**CITY OF PORTLAND, MAINE
DEVELOPMENT REVIEW APPLICATION
PLANNING DEPARTMENT PROCESSING FORM
Planning Copy**

2008-0107
Application I. D. Number
7/9/2008
Application Date
503-525 Presumpscot Street
Project Name/Description

RE: 503-525 Presumpscot Street
Minor Site Plan Review
Application #: 2008-0107
CBL: 415-B-6

**BOUNDARY SURVEY/SITE PLAN
PROPOSED NEW BUILDING AND ACCESS**

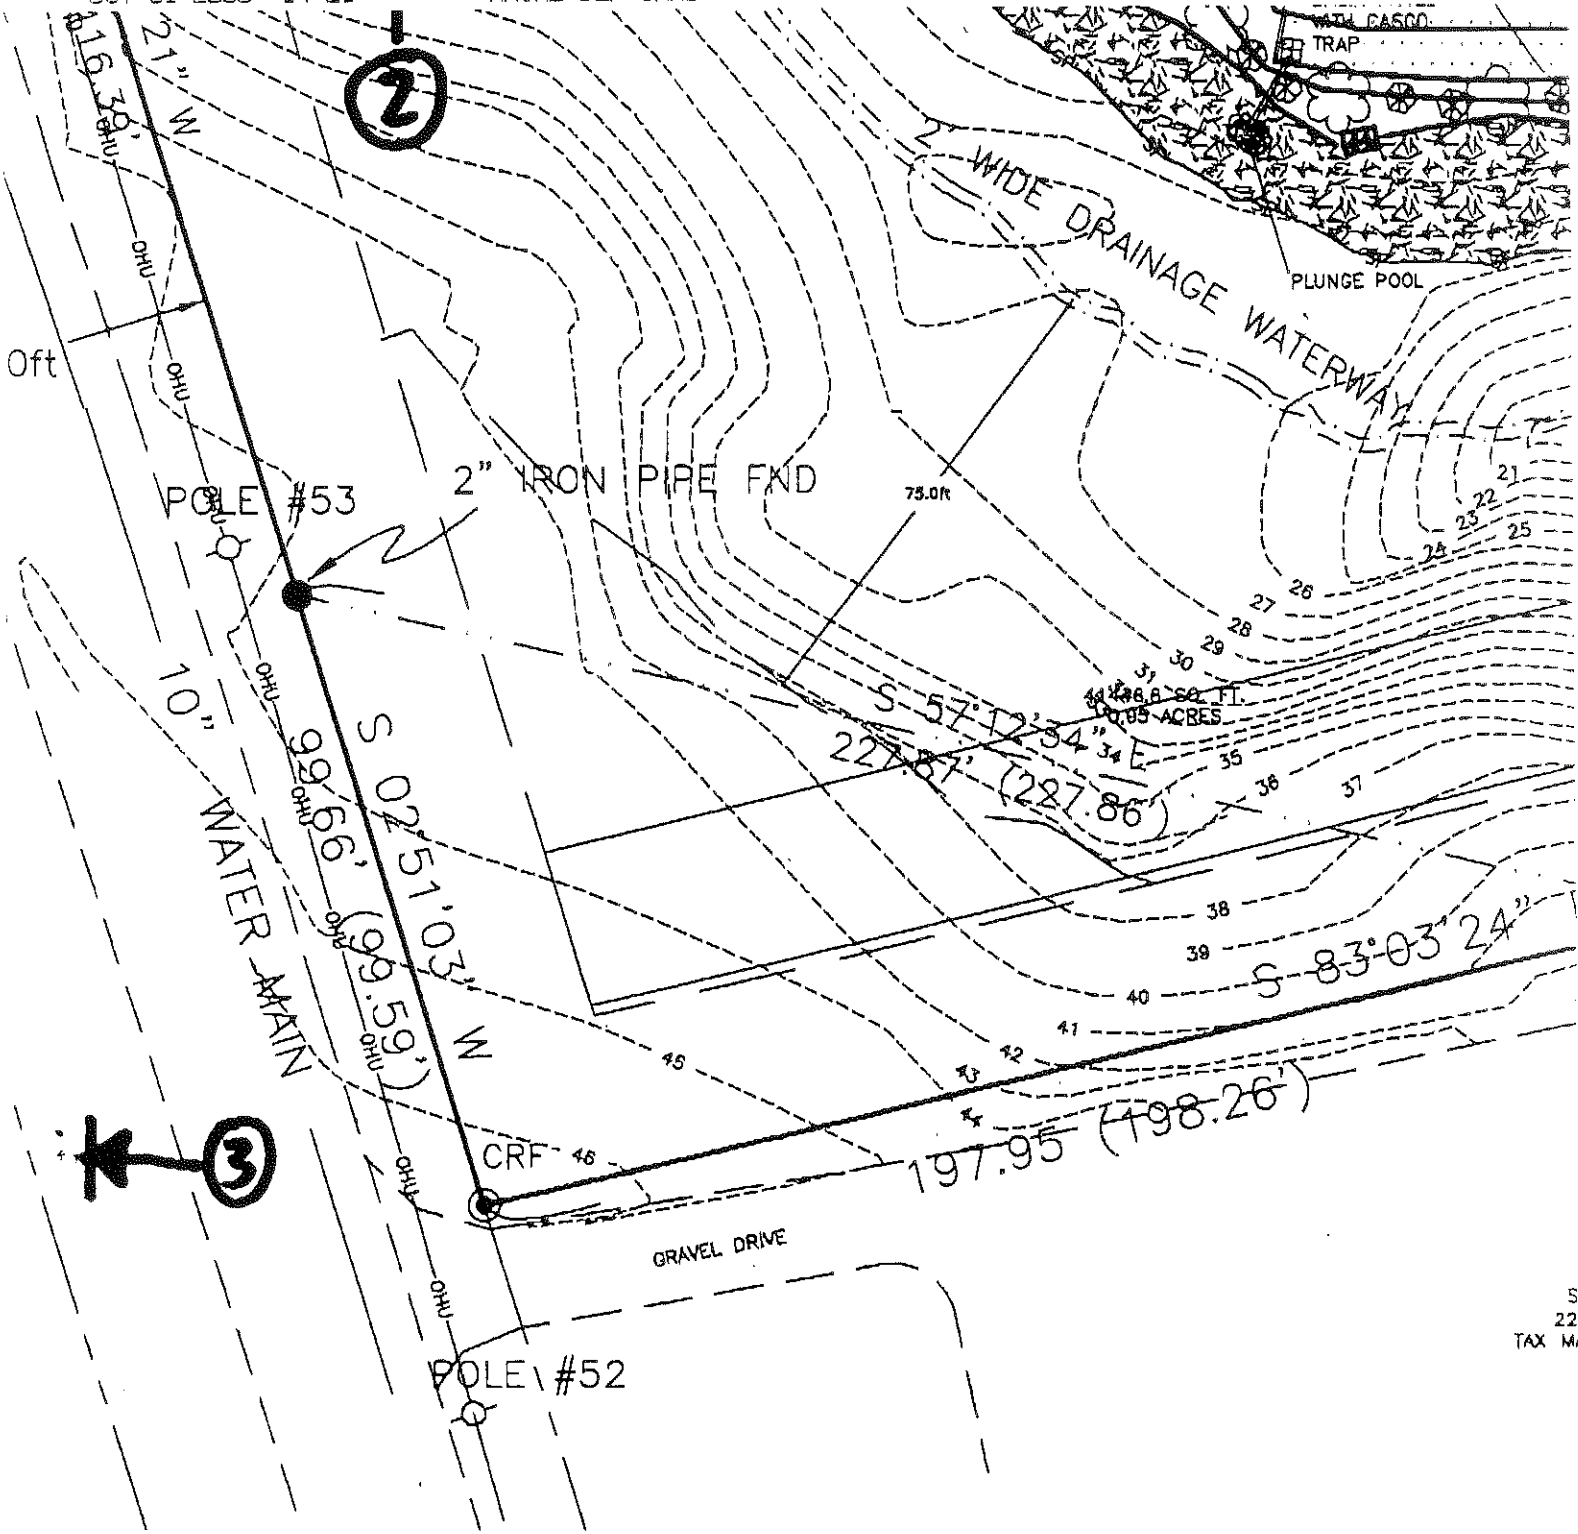
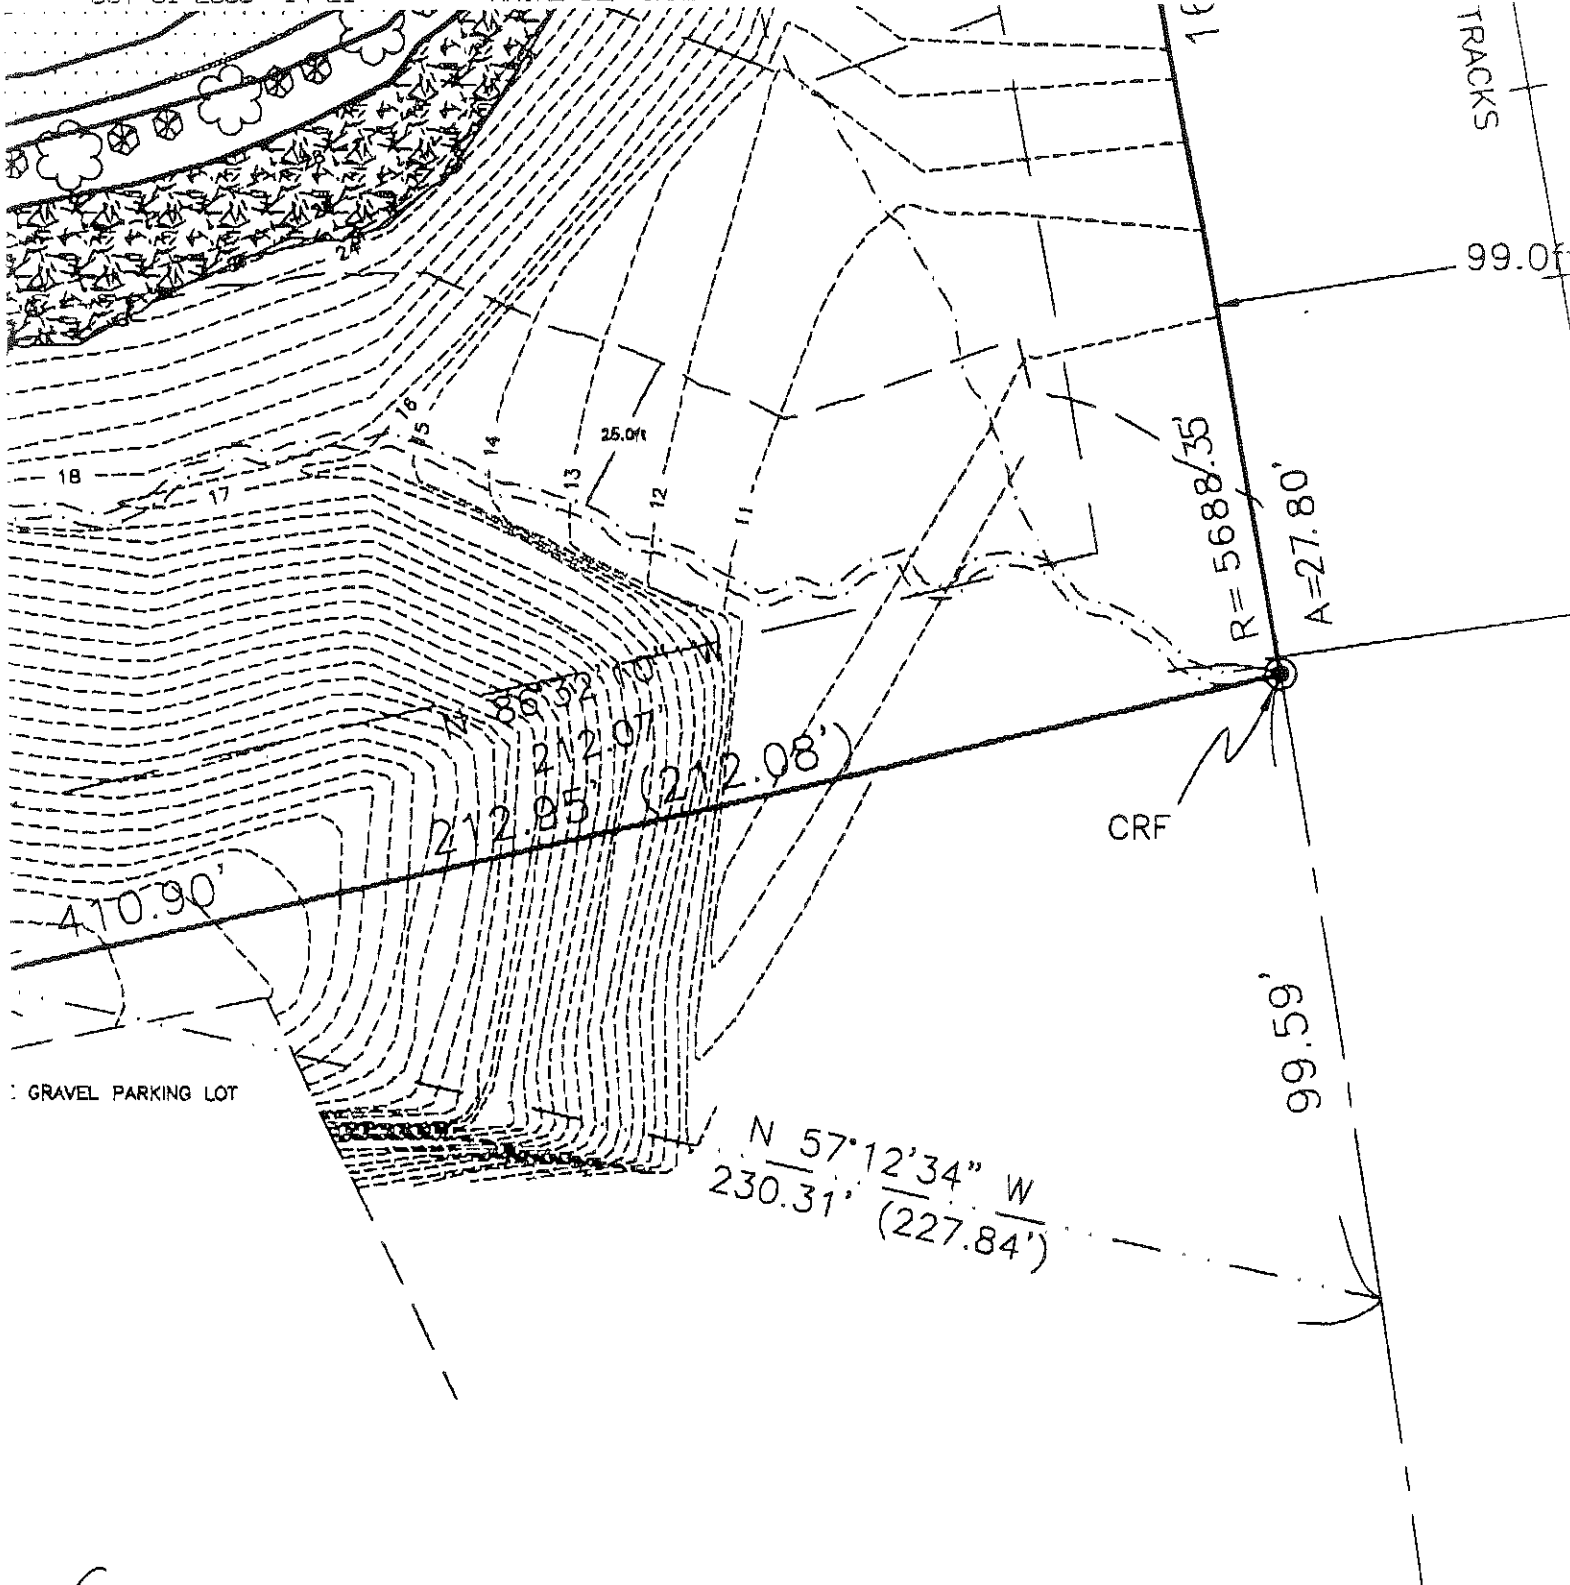
This property is located within an I-M Zone. The submittal is very weak. There is no cover letter explaining the use and other aspects of the submittal. I am not sure what a "multi-unit storage" use is intended to be. Are these self-storage units or are they intended to be storage for building contractors? The units appear to large. Do they have storage areas and accessory offices? No floor plans were submitted and no building elevations were submitted. The applicant must supply this needed information before I can make a final decision on use, setbacks and height.

The site plan does not have a scale on it. A 30 scale does not accurately work for the 160' length of building. The plans should be accurately scaleable with a common scale.

The site plans also give several lot sizes - 130,817.7 sq ft and 130,680 sq ft. The information given for the lot size should be able to be much more accurate than rounding off to a couple hundred square feet.

DRAWN BY: RTG
CHECKED BY: KMcK
SCALE: 1" = 30'
DATE OF SURVEY: 08/16/2007
JOB NUMBER: 2007104
SHEET: 2 OF 4
DRAWER: 2007 NO: 104

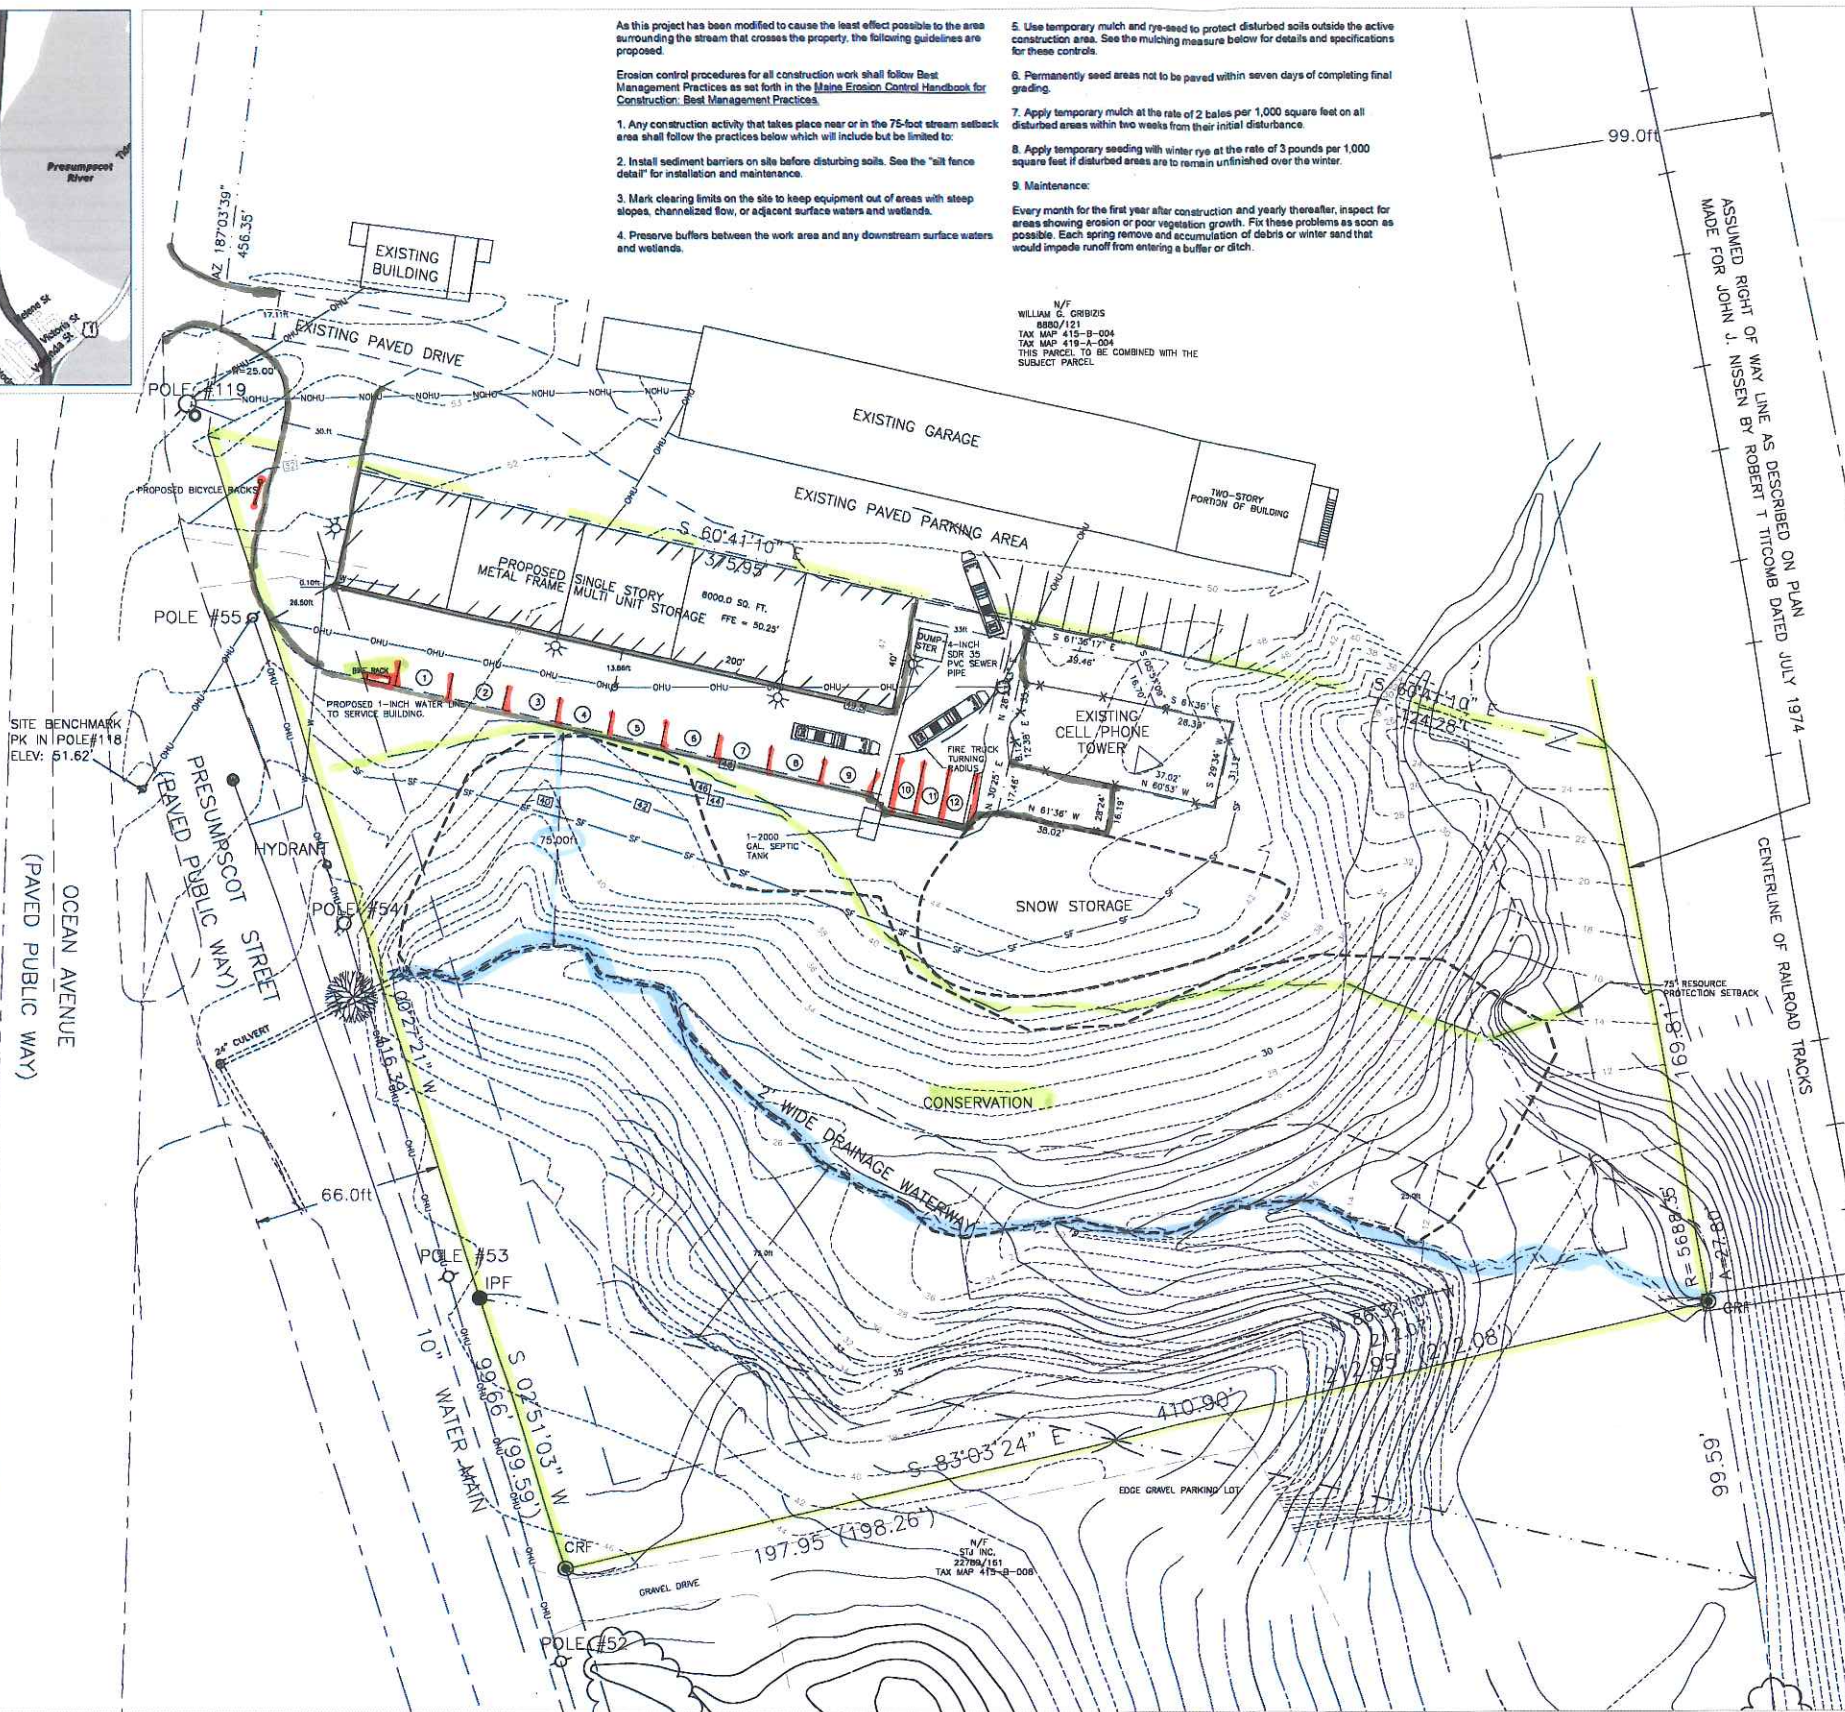
The submitted boundary survey/site plan is difficult to review due to the quantity of information contained on a single plan sheet. Separate existing conditions and proposed conditions plan sheets should be submitted when you submit your revisions. Additionally, as part of the proposal includes the merging of two abutting parcels into a single parcel, these plans should include the entire parcel along with accurate dimensional information in the general notes.

1. The current plans show pavement as close as 8 ft to the property line along Presumpscot Street. There is a 10 ft minimum pavement setback from lot boundaries required in the IM Zone.

2. The new plan shows a new building and parking lot at the southern end of the property. The assumed pavement is also not the required 10' from property lines, only 9'. Zoning requires a use to be declared for a full review. The proposed building is also showing access from an abutting property. Nothing has been submitted showing that appropriate easements have been obtained by the applicant.

3. Please explain the area labeled "conservation" on the submitted site plan. *— need deed language **
4. Even though this lot has merged with another, the submitted plans do not reflect the change in the lot size and other information within the "General Notes". It will be necessary for the surveyor to accurately represent the new lot size and explain how it impacts a zoning analysis (impervious surface ratio etc).

The survey and site plan have been separated into two drawings. Existing conditions are now shown on the Boundary Survey/Ex. Conditions Plan, proposed conditions are shown on drawing C1 Layout & Materials Plan.

The Survey drawing has been updated to accurately represent the lot size and related calculations. The zoning analysis has been moved to Drawing C-1 Layout & Materials Plan.

All proposed site information has been removed from the survey plan. Proposed improvements are shown on Drawings C1 & C2.
